**TENDER 16-20**

**WATER TREATMENT BUILDING**

**ADDENDUM NO. 5**

October 7<sup>th</sup>, 2016

NO.	REVISION/ISSUE	APP'D BY	DATE	CONSTD BY	DATE
2	ADDENDUM 5	AC	16/10/07		
1	ISSUED FOR TENDER	AG	16/09/02

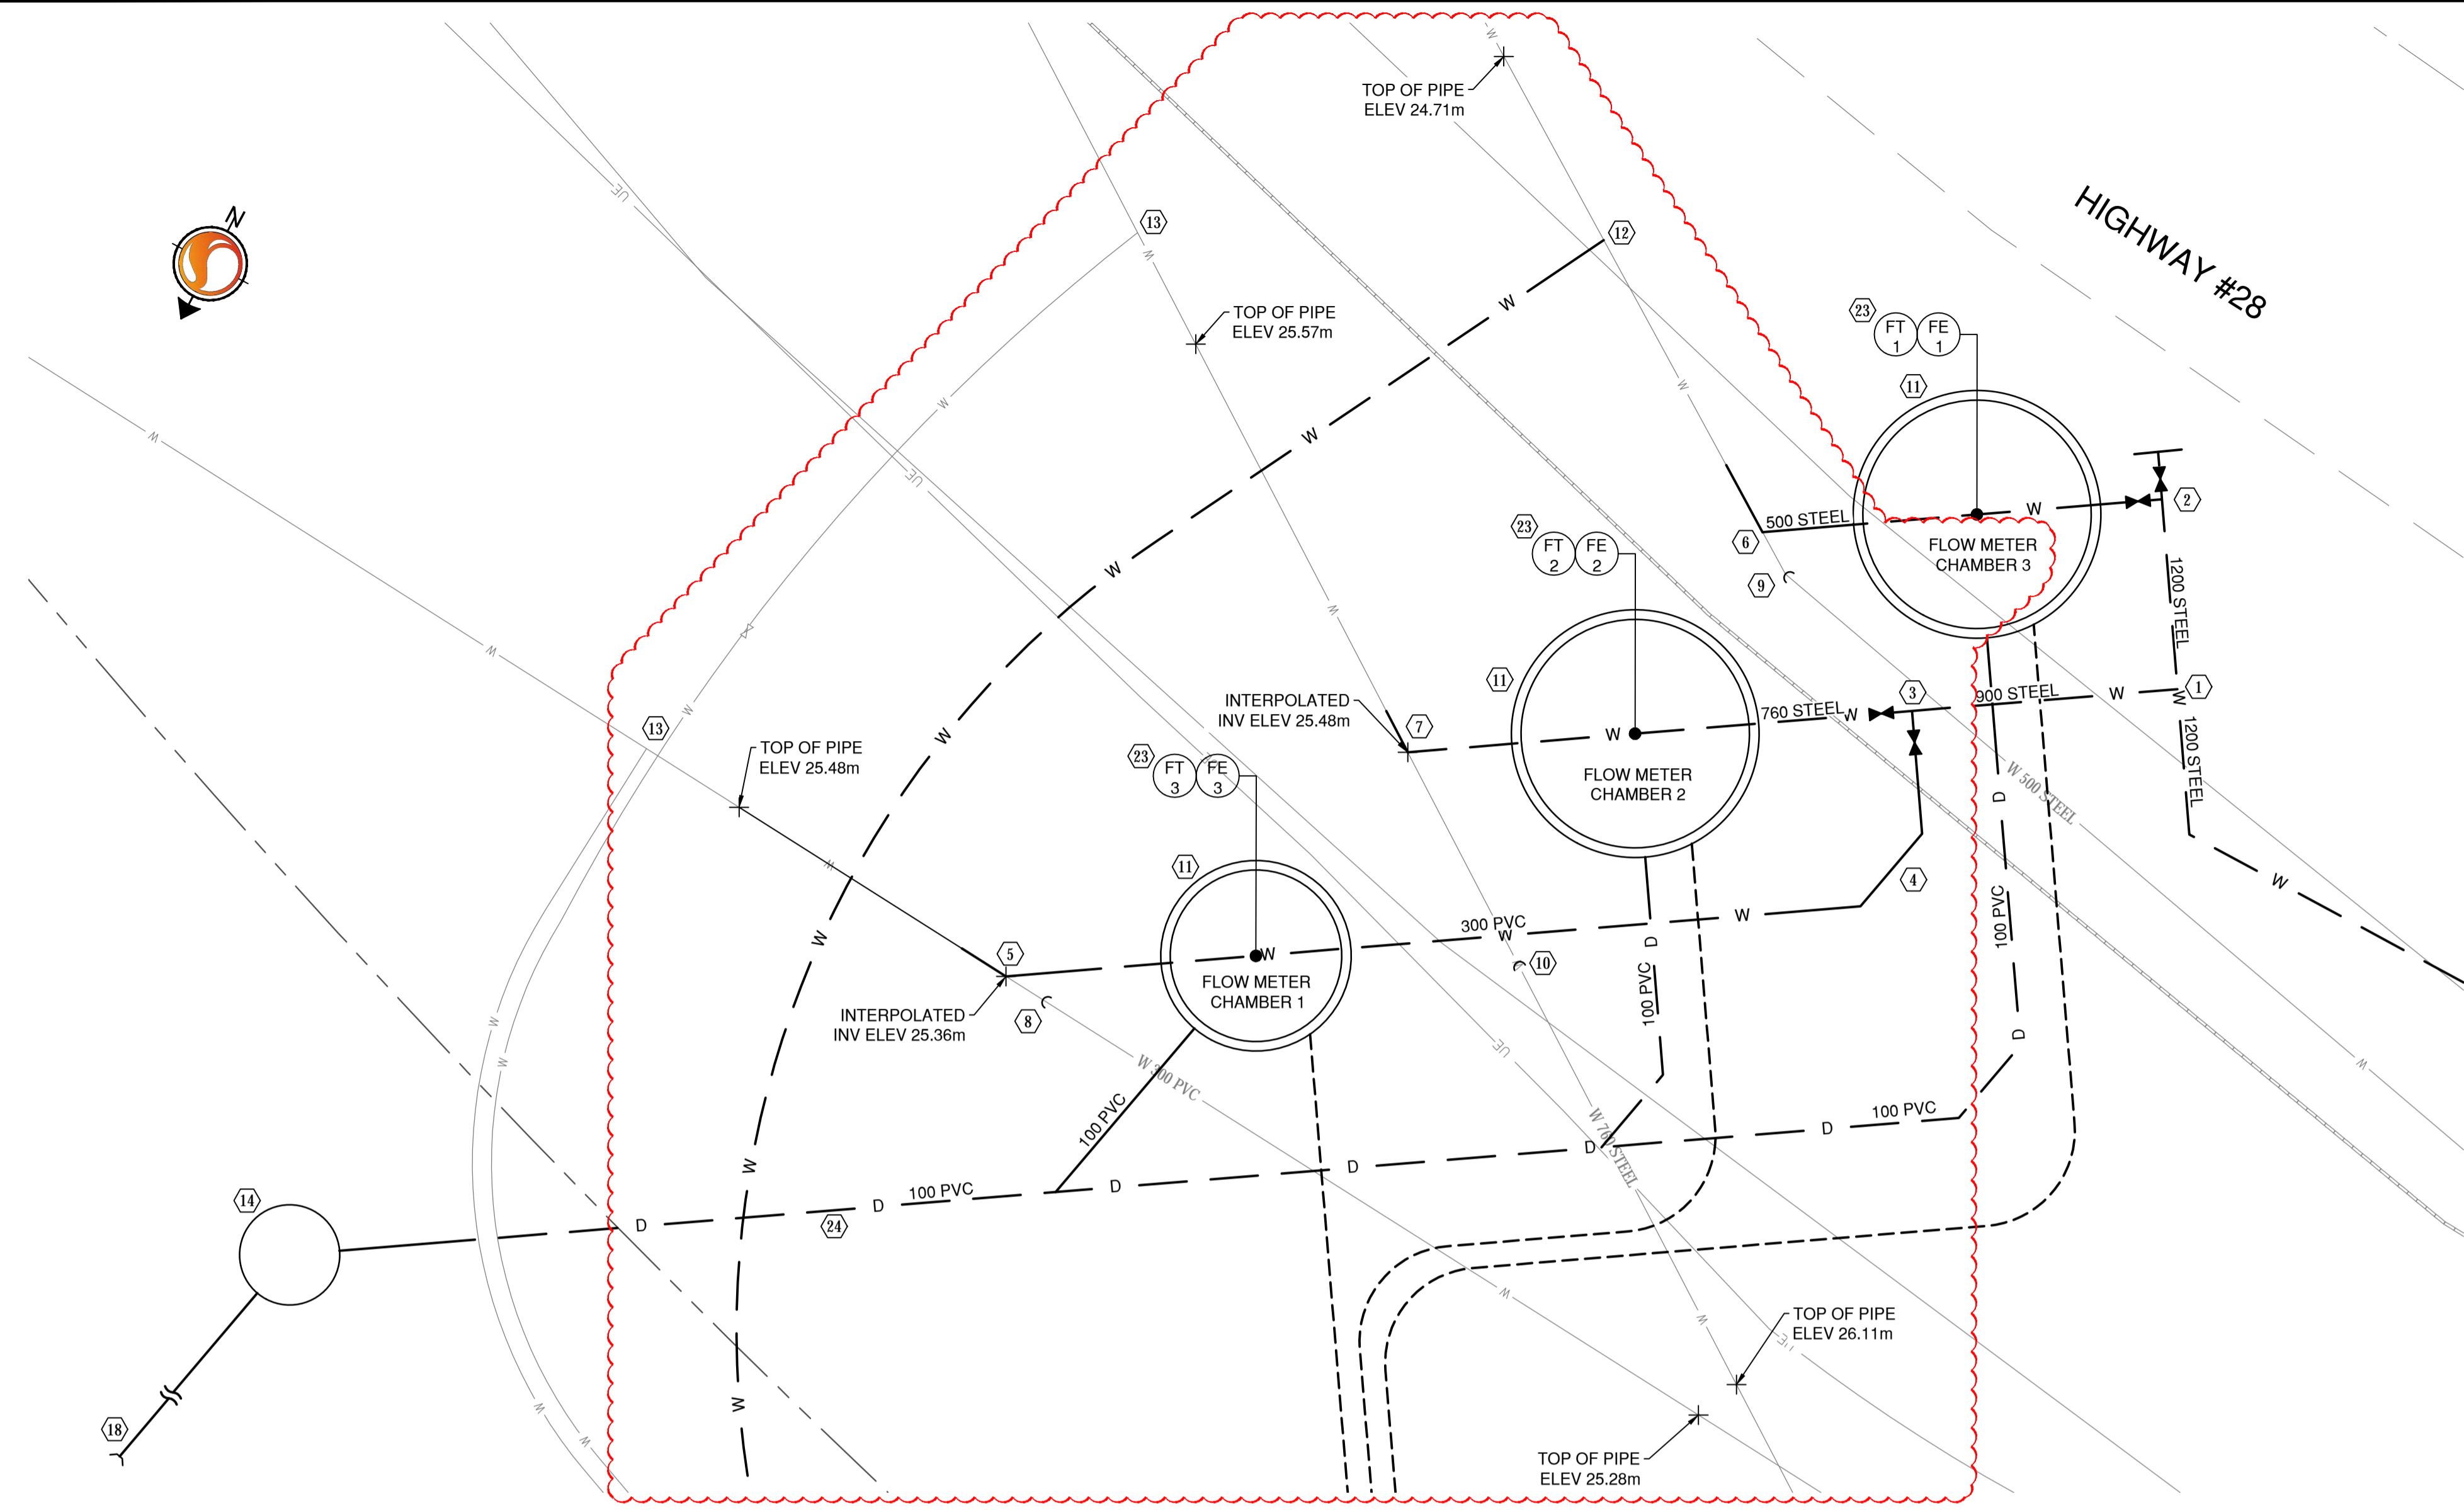
Pipe size – ‘TW’ process commodity – please confirm that the nominal pipe diameter is to be 1050mm. The continuation drawing (for the buried carbon steel pipe) on Sheet C103 indicates this line is to be 1000mm  $\Phi$  out in the yard. No reducer or expander is shown on the drawings in between the 1000/1050 mm transition point.

It was our understanding at the site visit that all site clearing had been completed and all remaining work would be carried out within the currently cleared area. It appears that the top of slope cut line indicated on drawing C103 could be beyond the tree line. Please provide the clearing and grubbing limits on a drawing or provide where the existing tree line is with respect to the top of slope, so that the area of clearing and grubbing can be calculated.

**Replace Clause 1.1.2.17 with** "Standby Generator, double-walled fuel tank shall be installed in a sound attenuated and weathertight E-House enclosure, access platforms as required and all accessories to be supplied by the Supplier. The equipment will be installed and commissioned by the Contractor. Allowance will be made to install a fuel tank on the exterior of the E-House, provided that additional space is not required; use the E-House footprint shown in drawing C103 – Site Utilities".

TITLE: PROPOSED RAW WATER SUPPLY MAIN HIGHWAY #28 TREATMENT BUILDING - CONTRACT 2	DRAWING NO. 15-508- C202
JOHN HART WATER QUALITY CENTRE WATERMAIN TIE-IN DETAILS	PROJECT: 112311316
	REV. 2

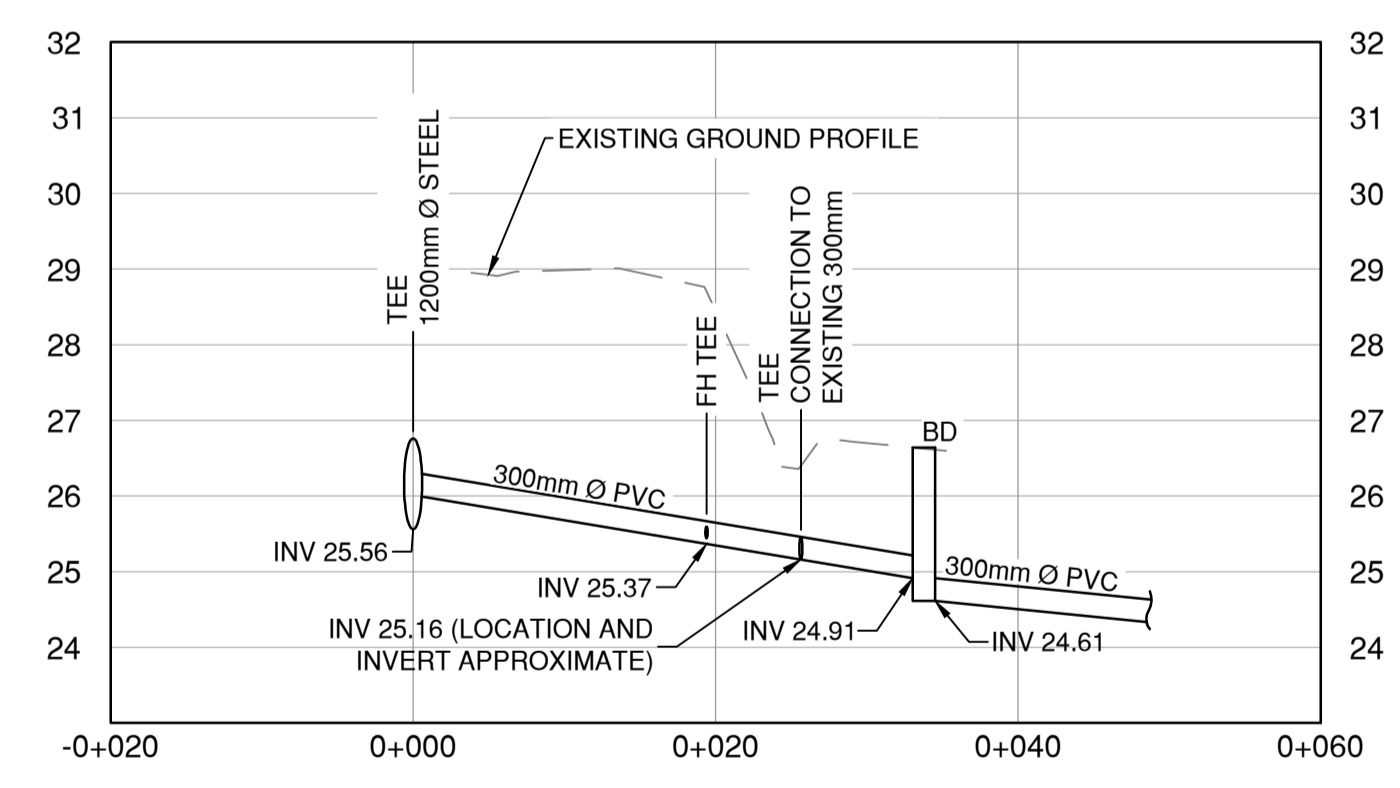
With reference to Drawing C202 please provide profiles for Connection Details 1 and 2. Specifically we need to determine where the new 900 mm steel, 760 mm steel, 250 mm PVC, and 100 mm PVC drain are to be installed relative to the existing mains on Detail 1. Similarly for Detail 2 please provide a profile showing new installation relative to existing supply mains.

Ref. Drawing 15-508-C202, the existing 500mm & 760mm Steel watermain in which we have to cut & tie into, could you please provide us with the specs of the lining & coating of these watermains?

Inverts have been provided refer to C202 for details.

**7 DAYLIGHT DRAINING BLOW DOWN CHAMBER DETAIL**  
SCALE: NTS

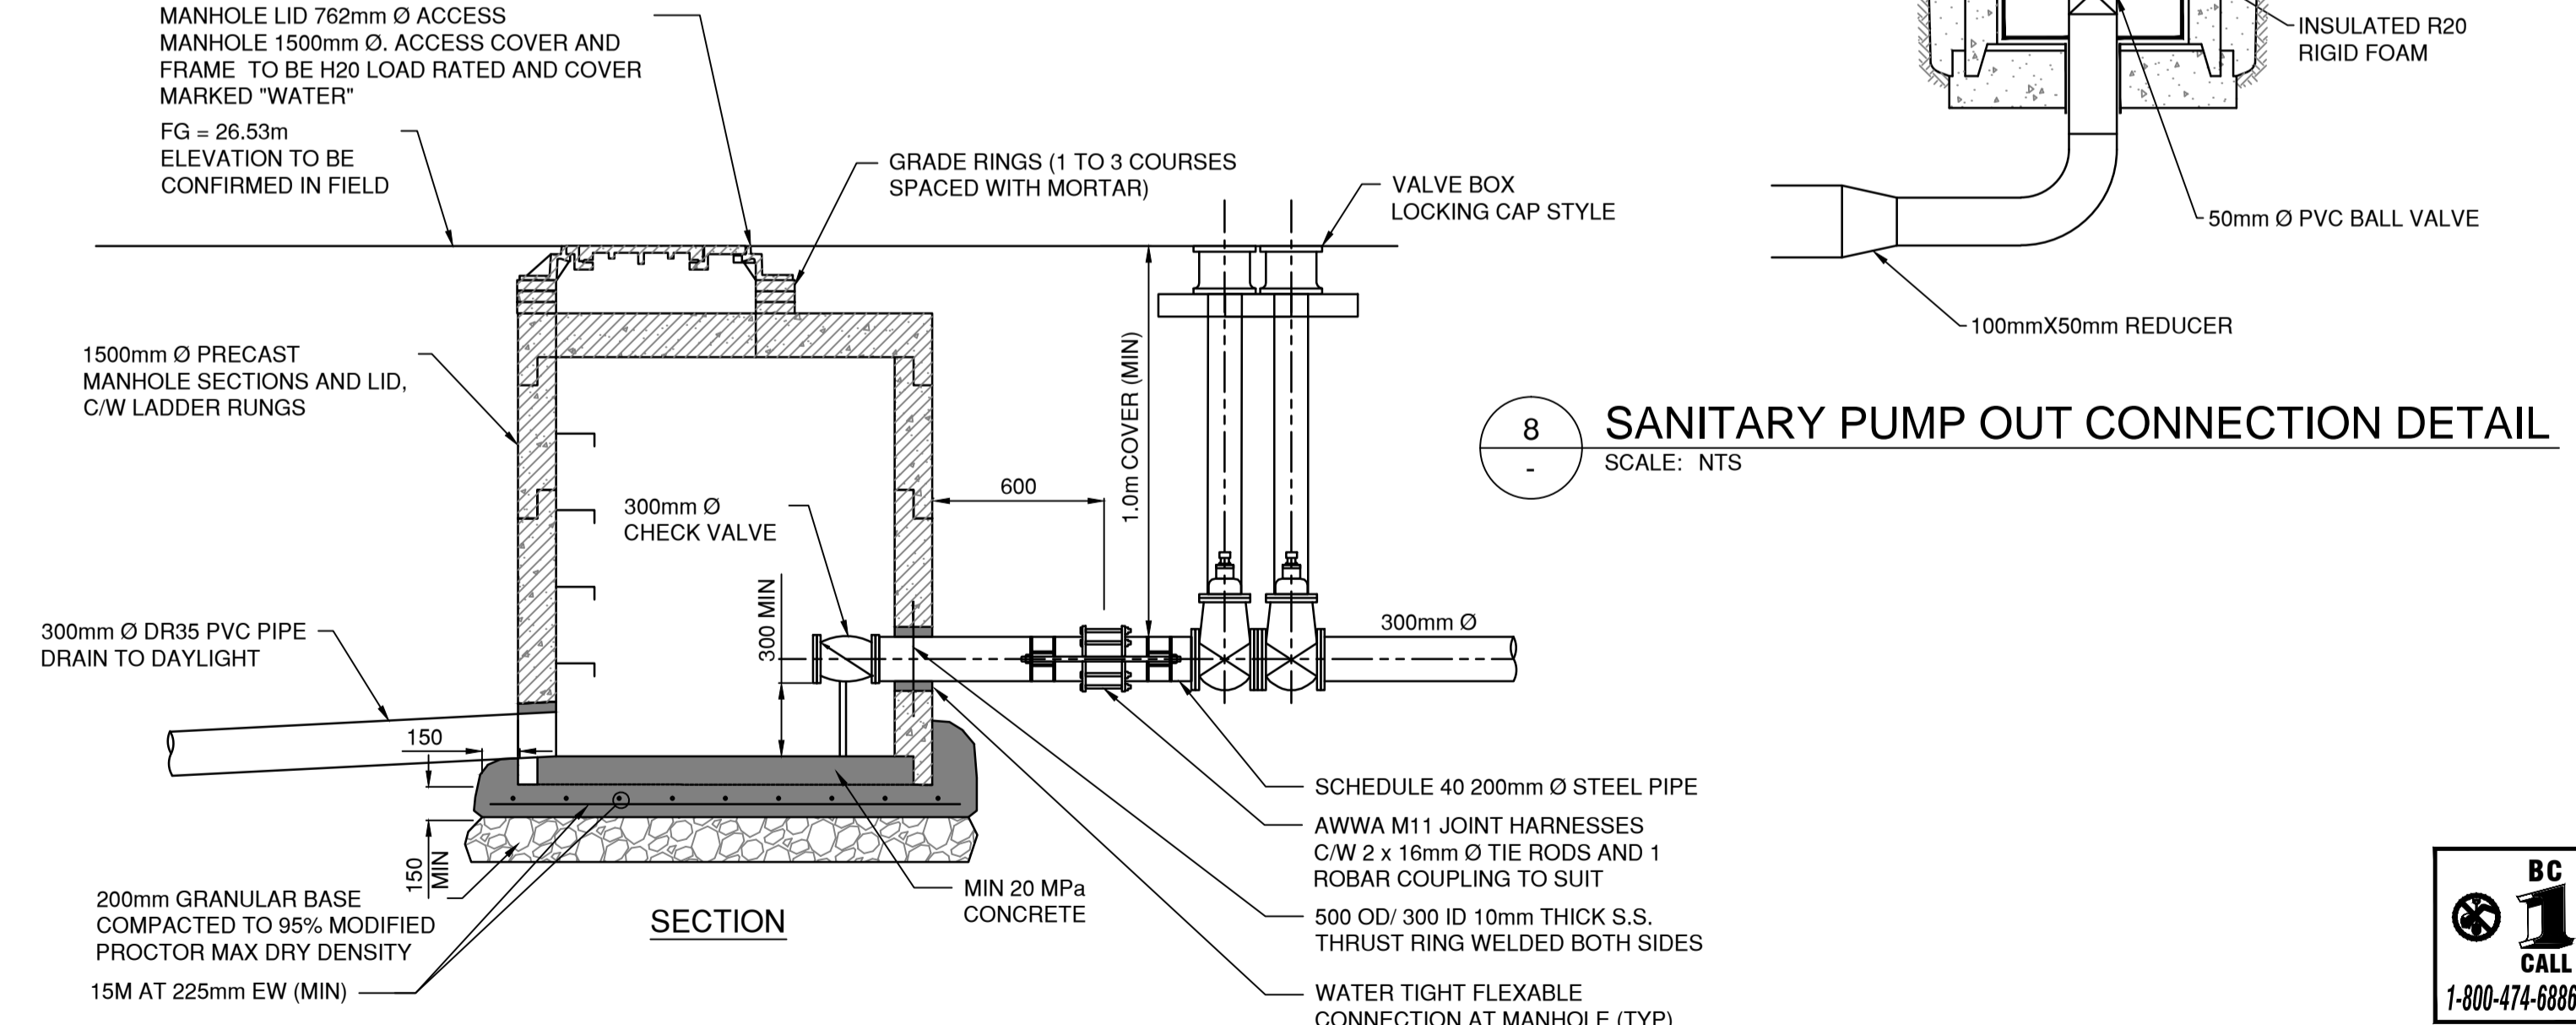
In response to a previous query Addendum #3 provided for a new detail on C302 for the blowdown. The check valve sizing was updated, however the gate valves sizing on the plan view remained at a smaller size to the piping.

Further to the detail for the blowdown it was previously asked what the depth for the blowdown would be. The added dimension (Addendum #3) for the blowdown indicated a "1.0 Cover Min". In the absence of profiles for the work at Hwy 28 and Powerhouse Road (previously requested but nothing provided yet), are we to price this at the minimum 1.0 M cover? In all likelihood this chamber will be much deeper and require a deeper chamber.

Refer to drawing C302 in Addendum 5.
